RESOLUTION NO. 5367-18

A RESOLUTION APPROVING A MINOR ARCHITECTURAL REVIEW APPLICATION FILED BY THE TUALATIN PROFESSIONAL CENTER FOR PARKING LOT IMPROVEMENTS LOCATED AT 6464 SW BORLAND ROAD (MAR17-0041).

**Res. No. 5367-18 / MAR 17-0041 – Attachment A
ANALYSIS AND FINDINGS**

| <p>DEMOLITION AND EROSION CONTROL PLAN</p> | | |

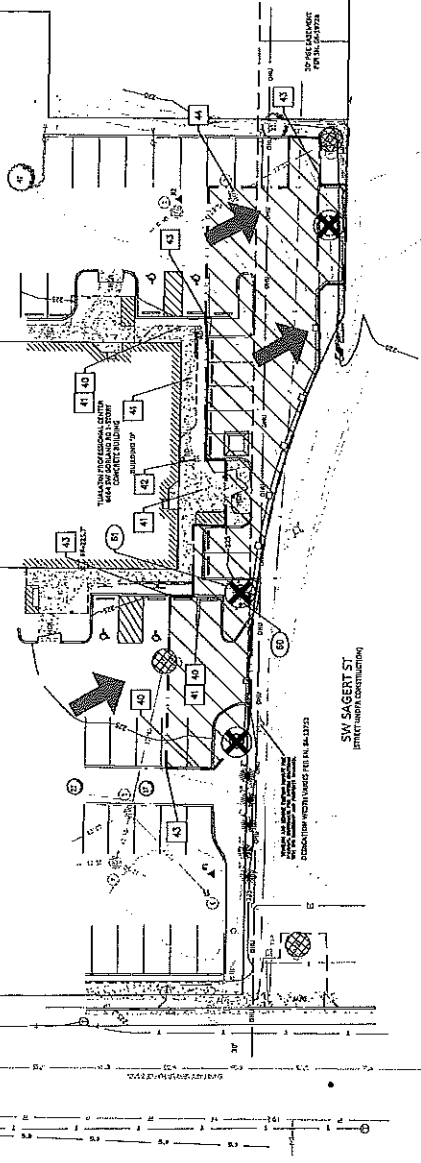
7. The applicant must apply for and obtain a Public Works Permit for all work within public right-of-way and an Erosion Control Permit for all disturbed area.

- a. Provide an engineered plan that shows plan and profile of the proposed driveway connections and proposed pedestrian connections. All improvements must match back of sidewalk grades currently being constructed by Lennar Homes as part of public works permit number PW16-0211. Plan must meet requirements of Engineering Division for review and approval pursuant to the Tualatin Public Works Construction Code and must be approved by the Engineering Division.

- b. Show back of sidewalk grades that match the elevations of SW Sagert Street right-of-way improvements currently being constructed by Lennar Homes as approved in Public Works Permit No. PW16-0211.

The applicant has satisfied this condition in Attachment 104 - Sheet C200, dated 5/2/2018; Sheet C300, dated 5/2/2018; Sheet C400, dated 5/2/2018; and Sheet C501, dated 5/2/2018.

| <p>kpff</p> | | <p>SITE AND HORIZONTAL CONTROL PLAN</p> | |

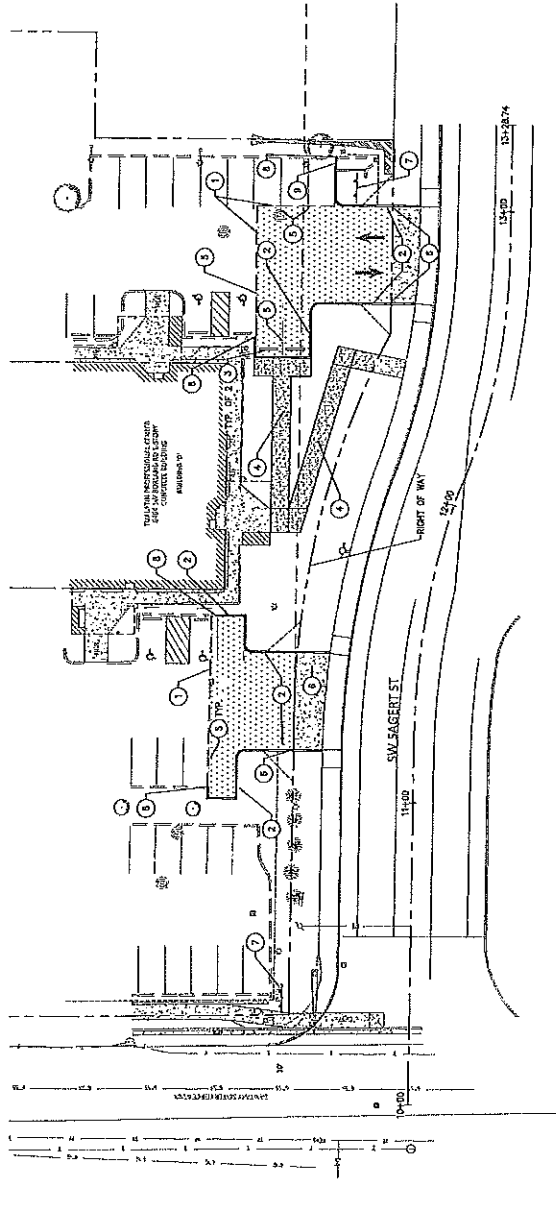
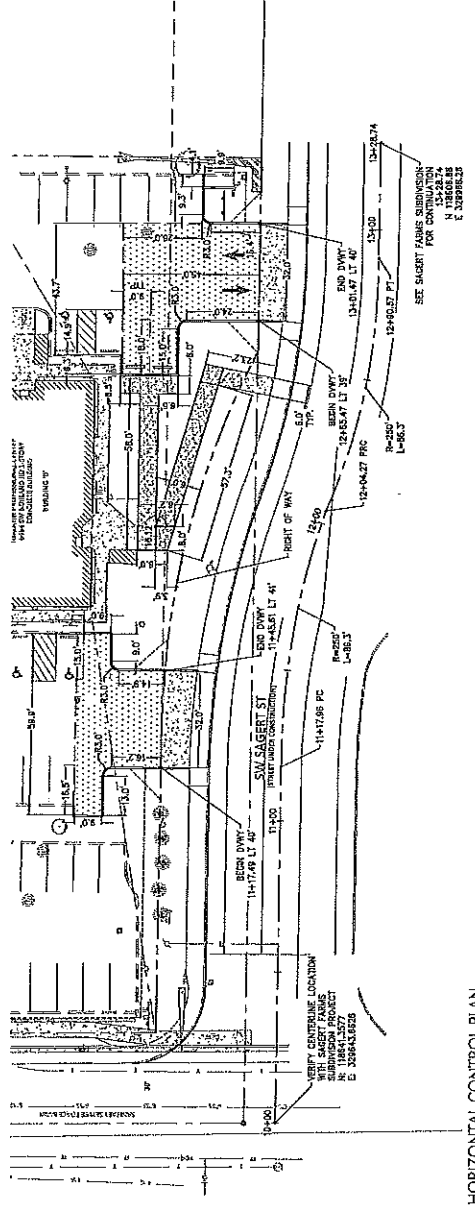
2. The applicant must submit plans that illustrates a six foot wide ADA compliant walkway between the main entrance of the southern building of the Tualatin Professional Center complex (Building D) and SW Sagert Street and install to approved plan set pursuant to TDC73.160(1)(a)(i).

5. The applicant must install landscape areas not less than five feet in width on each side of the southern two access drives located off of SW Sagert Street that extend for a distance of at least

twenty-five feet from the back of public sidewalk pursuant to the applicants revised plan set as seen in Attachment 104- Sheet C300 dated May 2, 2018 and pursuant to Resolution No. 6-18TPC.

6. The applicant must install two on-site access drives that are thirty-two feet wide for the first twenty-five feet from back of sidewalk pursuant to the applicants revised plan set as seen in Attachment 104 - C300 dated May 2, 2018 and pursuant to Resolution No. 6-18TPC.

The applicant has satisfied this condition in Attachment 104 - Sheet C300, dated 5/2/2018, Keynote 4.

The applicant has satisfied this modified condition in Attachment 104 - Sheet C300, dated 5/2/2018.

The applicant has satisfied this modified condition in Attachment 104 - Sheet C300, dated 5/2/2018.

DWY-1 PROFILE
SCALE: HORIZ. 1" = 10'
VERT. 1" = 2'

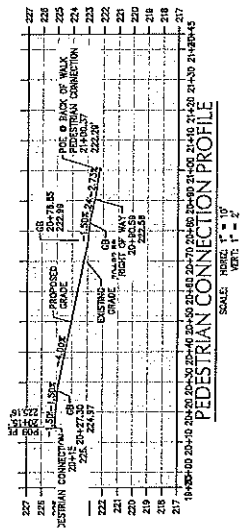
- c. If proposed pedestrian connection to the Sagert Street sidewalk is the ADA accessible route to the public right-of-way, then improvements in the right-of-way must meet ADA criteria set forth in the 2010 Public Rights of Way Design Guidelines (PROWAG), including running slope, cross slope, and all other relevant requirements.

TUALATIN PROFESSIONAL PLAZA
 PLANTING PLAN

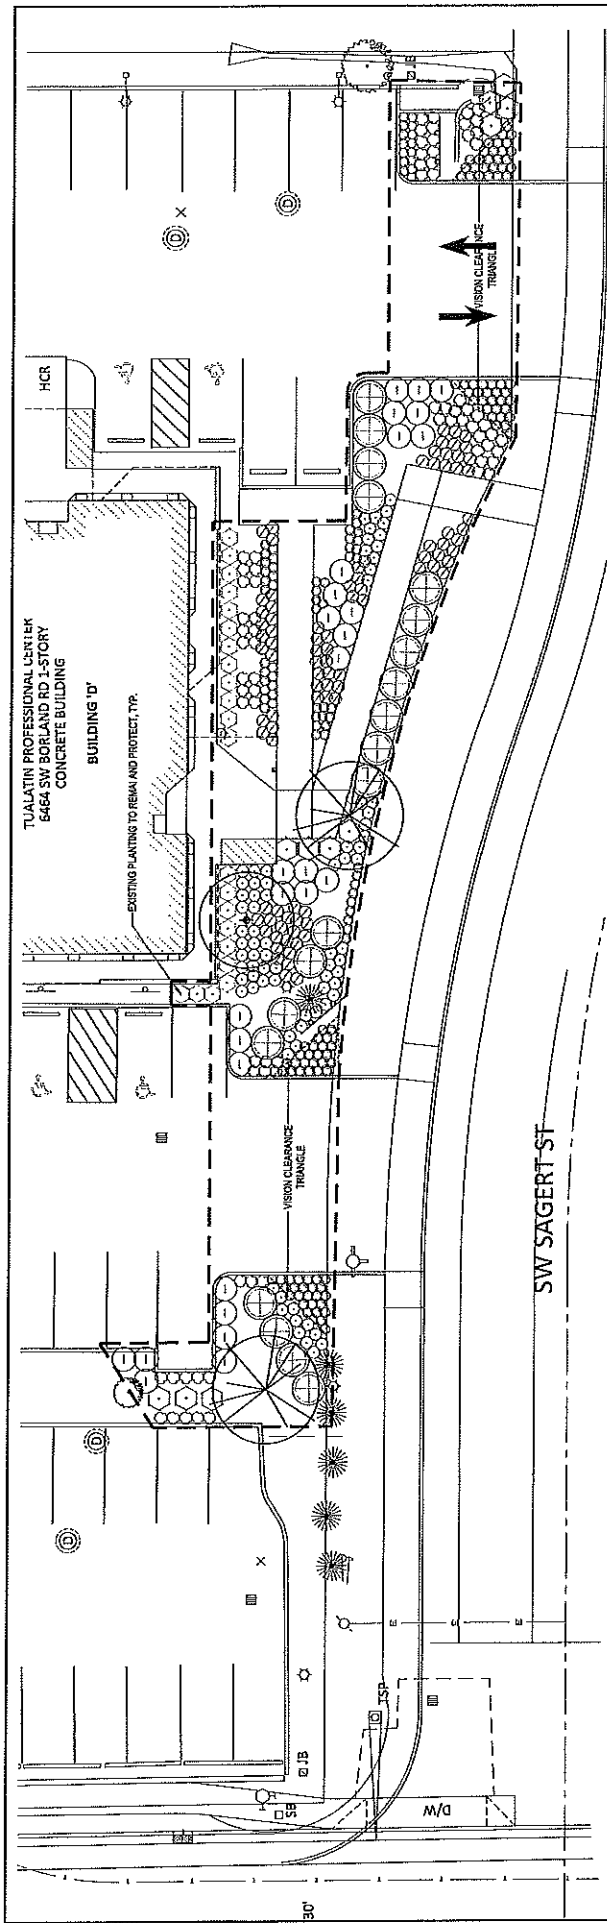
3. The applicant must submit a landscape plan that illustrates areas within the defined project area that are not occupied by buildings, parking spaces, driveways, drive aisles, and pedestrian areas are landscaped and install to approved plan set pursuant to TDC 73.310(3).

4. The applicant must submit a revised landscape plan that notes a clear zone will be provided at the proposed access drive entrances vertically between a maximum of thirty inches and a minimum of eight feet as measured from the ground level pursuant to TDC 73.340(1).

The applicant has satisfied this condition in Attachment 104 - Sheet L200, dated 4/23/2018.

The applicant has satisfied this condition in Attachment 104 - Sheet L200, dated 4/23/2018.
